**LEBANON PLANNING BOARD
OCTOBER 10, 2022 - 6:30 PM
COUNCIL CHAMBERS, CITY HALL OR
REMOTE VIA VIRTUAL PLATFORM
LEBANONNH.GOV/LIVE**

- C. *REVISED* - LWM Residential LLC, 1 Foundry Street (Tax Map 91, Lot 263), 25 Mechanic Street (Tax Map 91, Lot 267), and 43 Mechanic Street (Tax Map 106, Lot 34), zoned LD:** Request for Site Plan Review of a phased, 196-unit multi-family development including a new 4-story, 27-unit multi-family building with a parking garage on the ground floor at 43 Mechanic Street; a new 4-story, 31-unit multi-family building with a lower-level parking garage at 25 Mechanic Street, to be merged with 1 Foundry Street; and, at 1 Foundry Street, the renovation of the existing Woolen Mill building into 49 dwelling units, the renovation of the existing commercial building and boiler building into amenity spaces, construction of a 2-story parking structure, and construction of a new 5-story, 89-unit multi-family building with a lower-level parking garage, together with associated site improvements. Applicant also requests a Conditional Use Permit pursuant to Section 307.8.A to allow an increase in the maximum permitted building height. PB2022-36-SPR - Continued from S

PLANTING PLAN

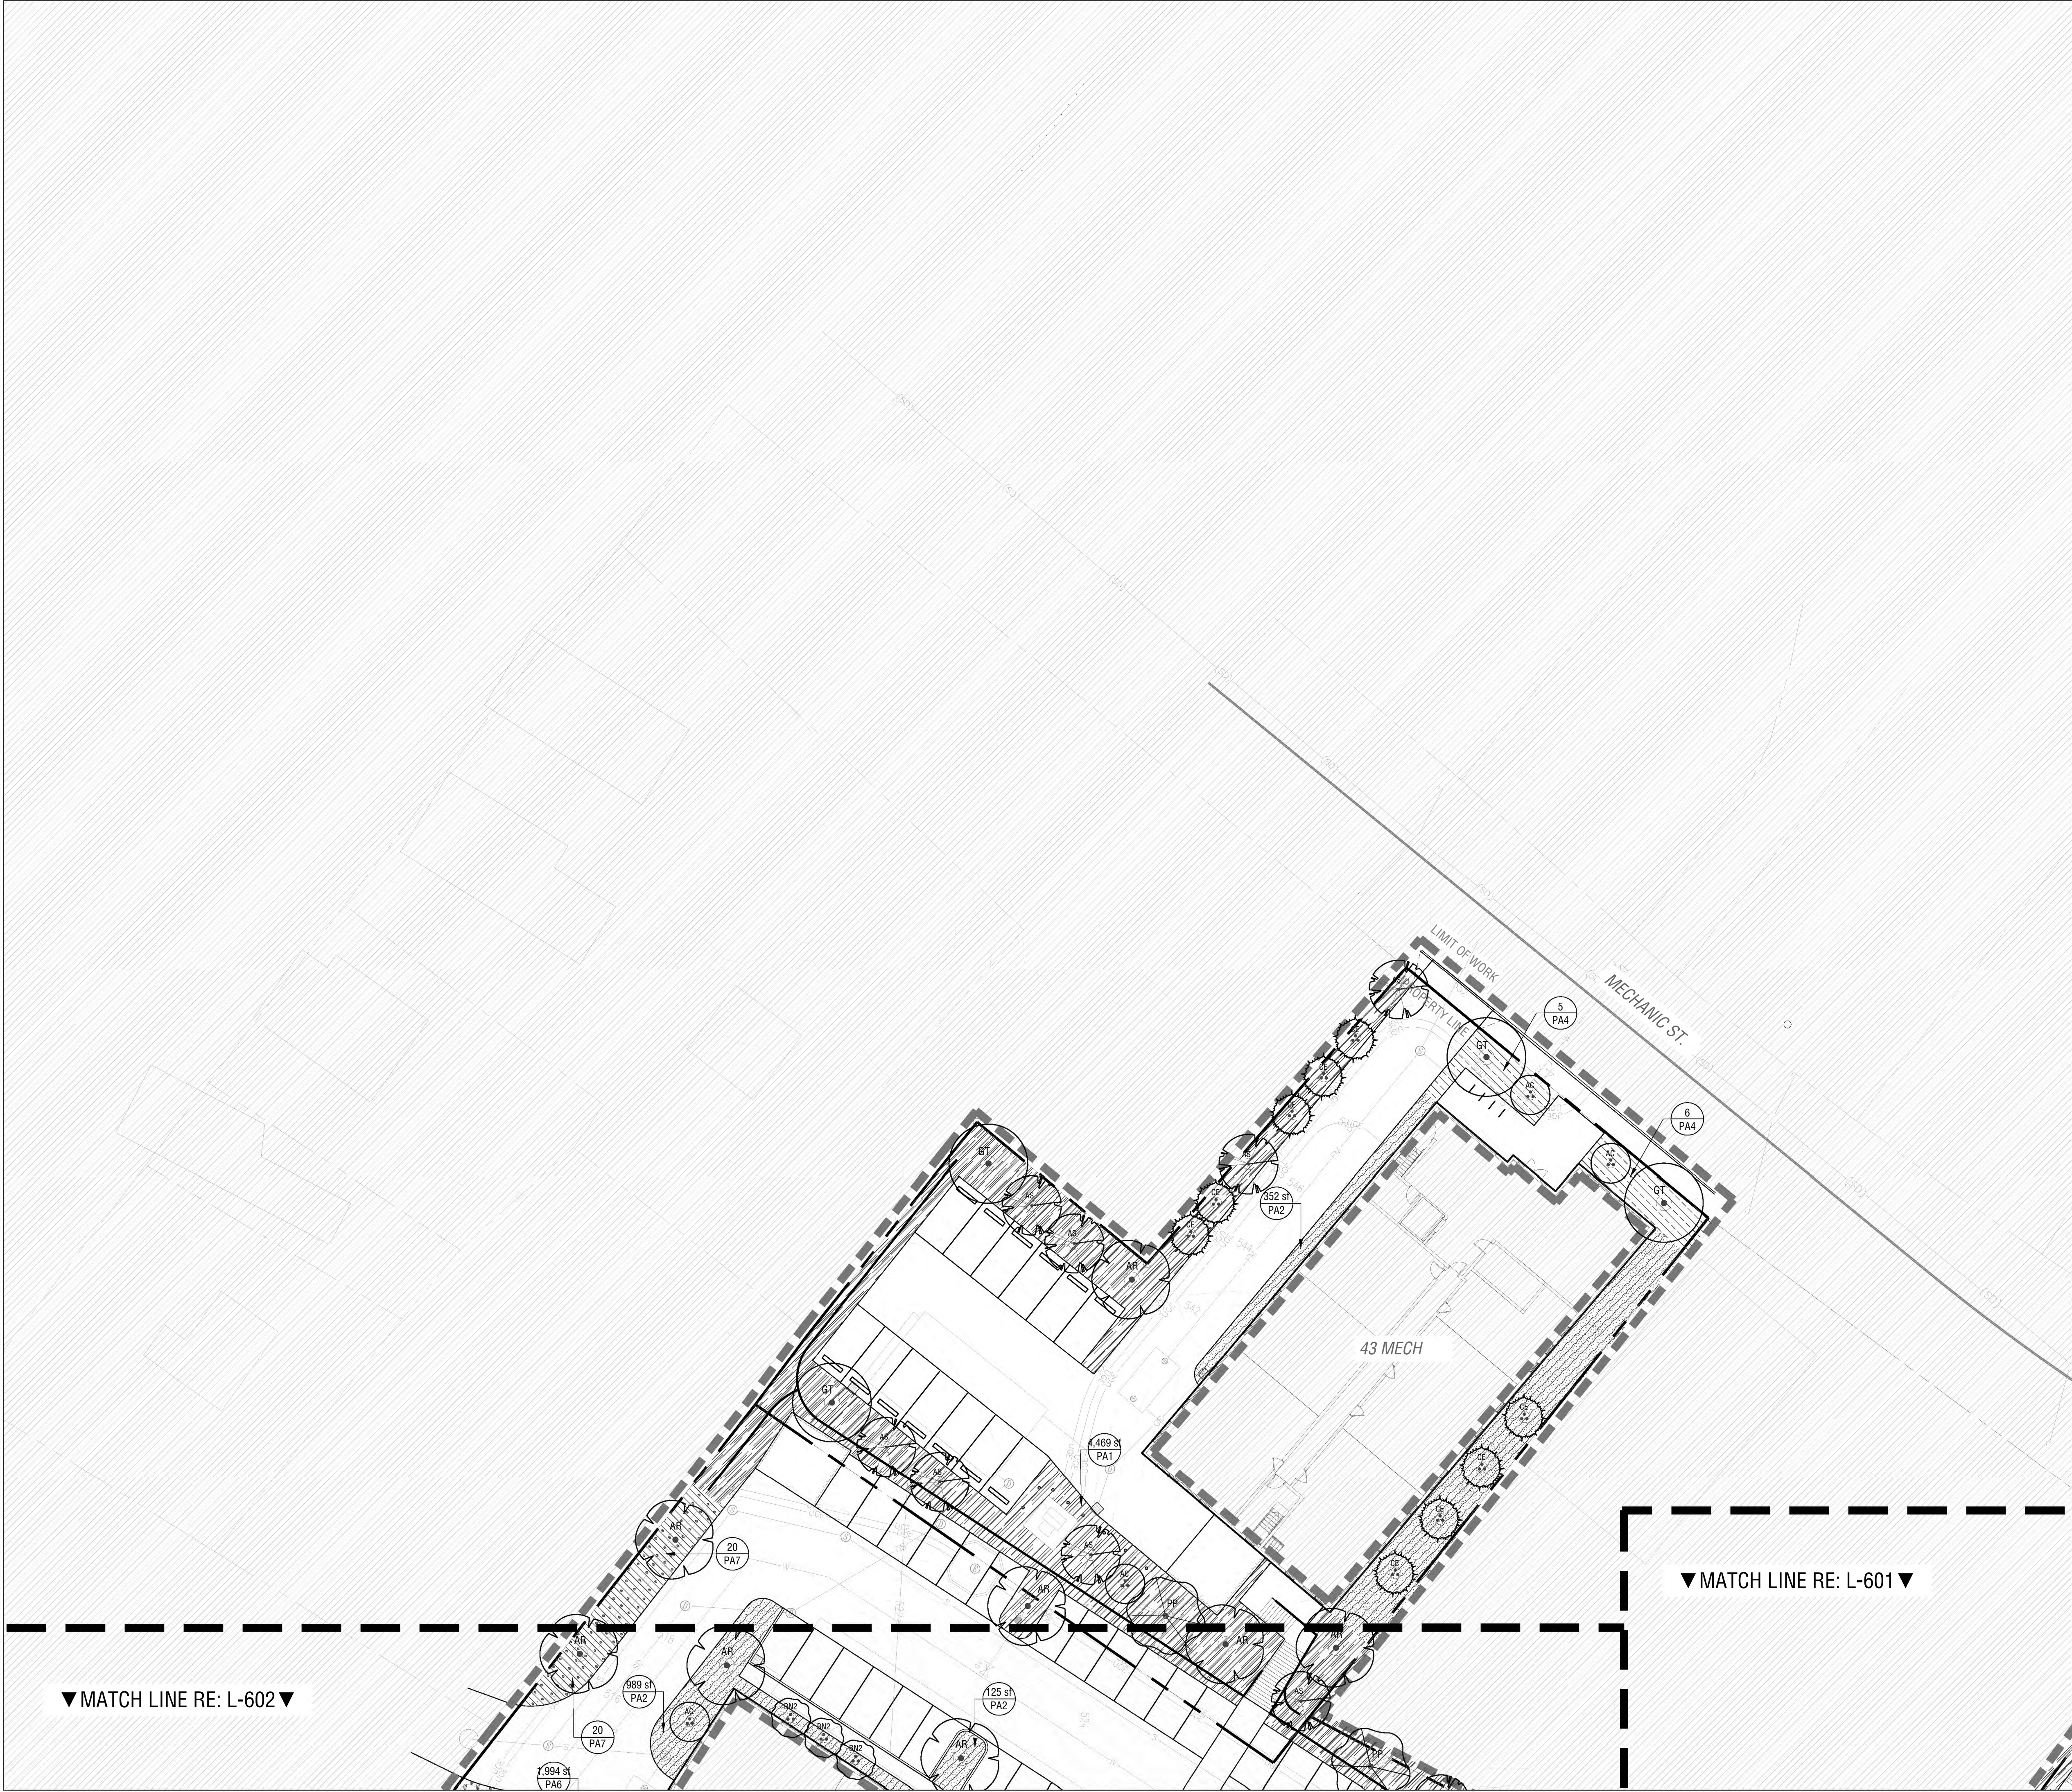
Sheets 42, 43 & 44 (Planting Plan)

- *OJB: There were proposed utilities under this area that conflicted with tree root balls. The utility lines have been relocated and trees are provided as shown in sheet L602.*

EXISTING MILL
ELEVATIONS

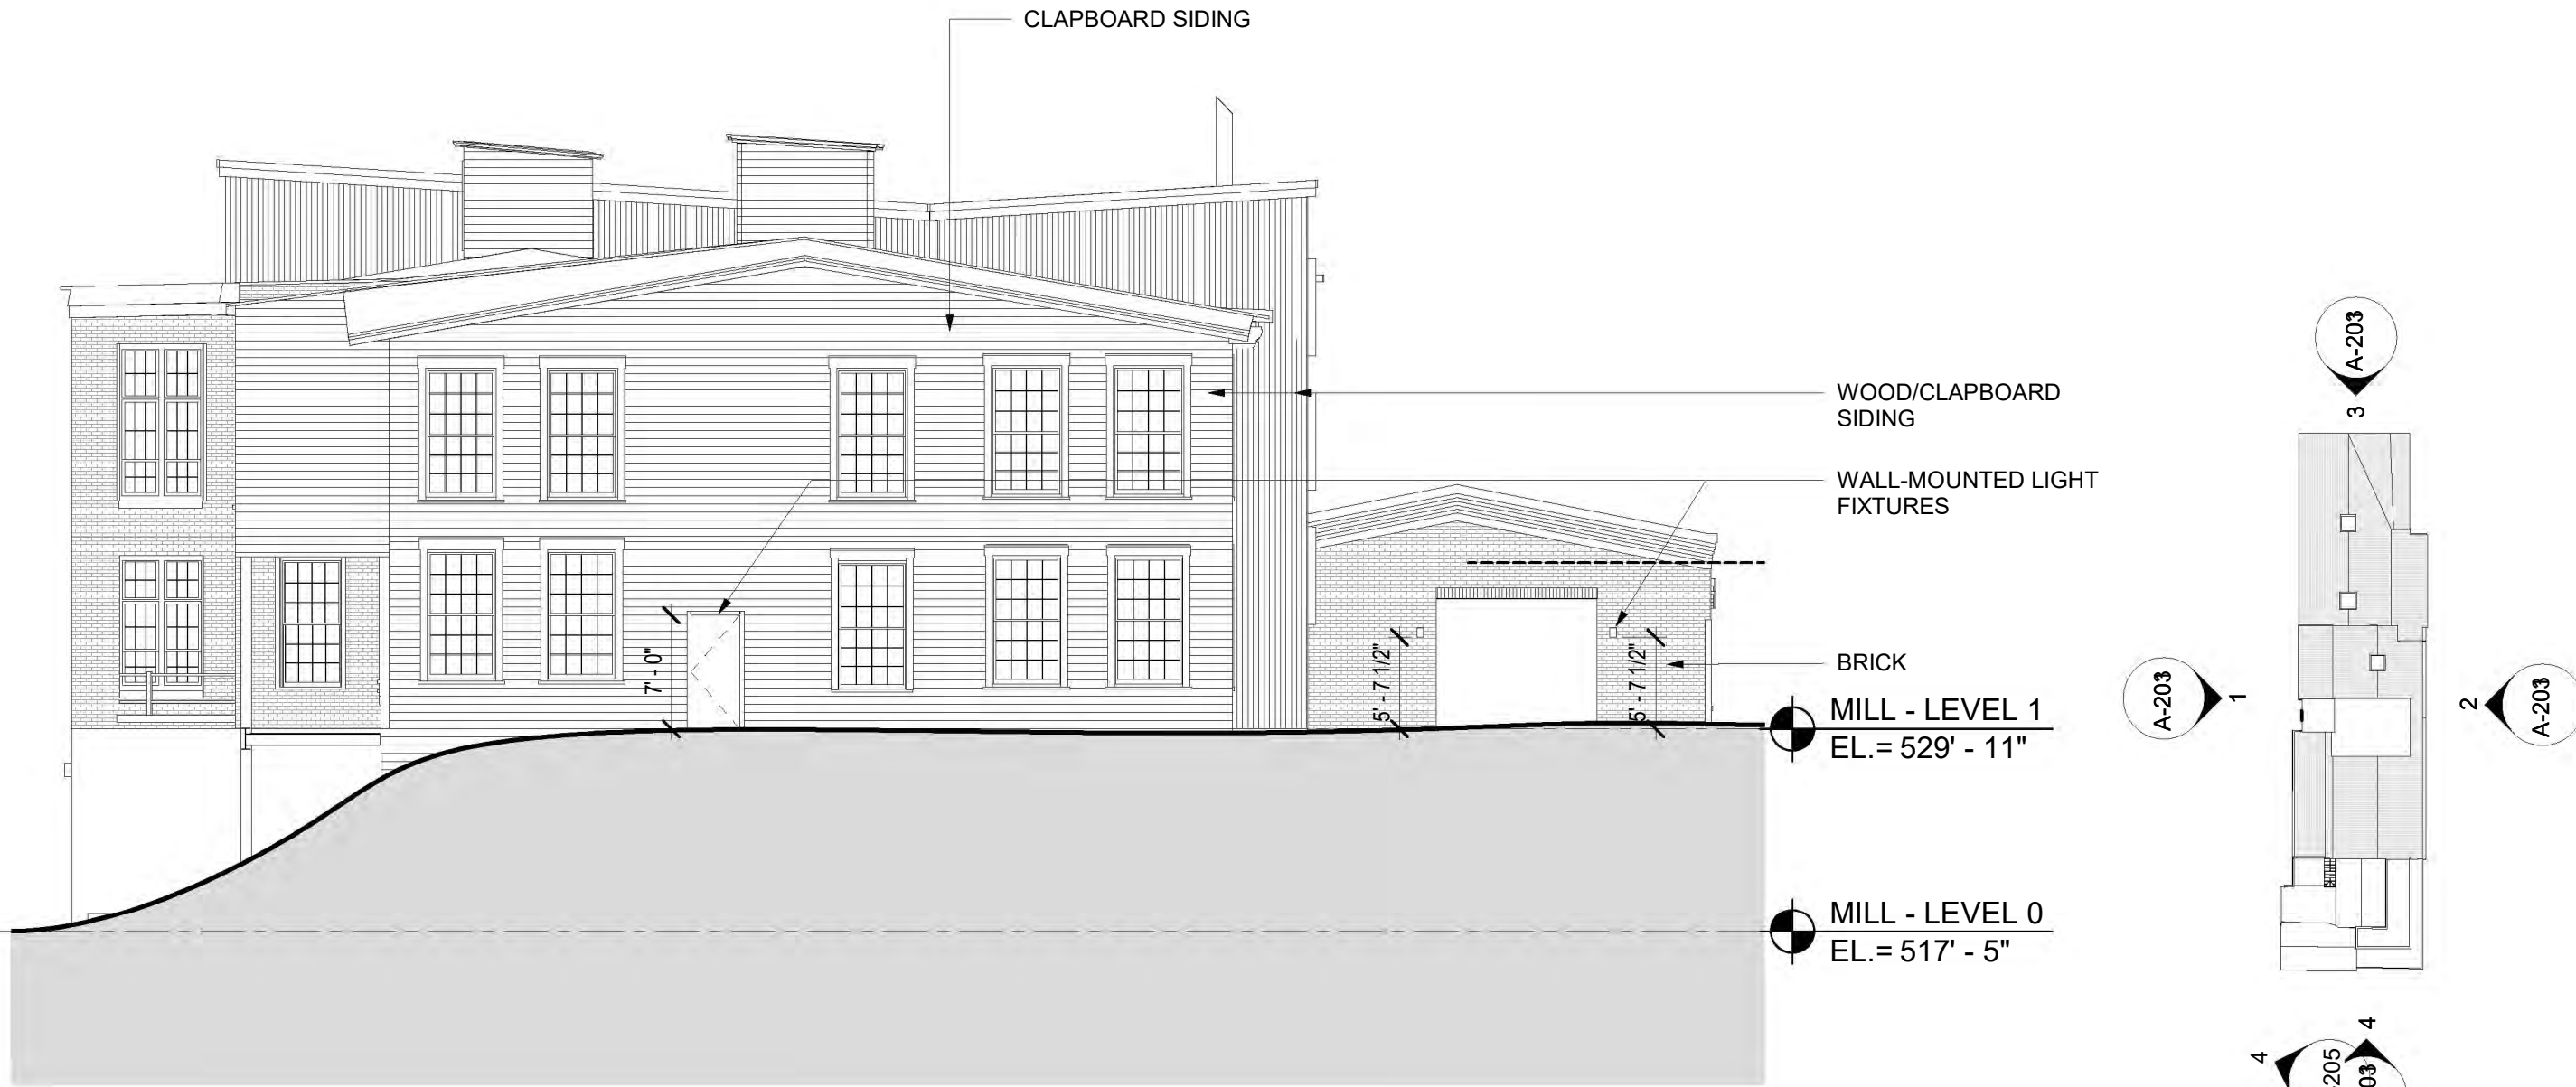
- *RODE: Street level story is a minimum of 12' floor to floor for all new buildings. See dimensions on sheets A-200, A-201, and A-202.*
29. In the Zoning Tables on the Cover Sheet and/or on the building elevations, identify the height of the street level story for each new building to demonstrate compliance with Section 307.8.C of the Zoning Ordinance which requires a minimum height of 12 feet as measured between finished floors.

- *RODE: Building heights are identified on elevations. See sheets A-200, A-201, A-202, and A203*
30. Add building heights to all building elevation sheets to demonstrate compliance with the maximum 55 ft. building height requirement (Section 307.2).
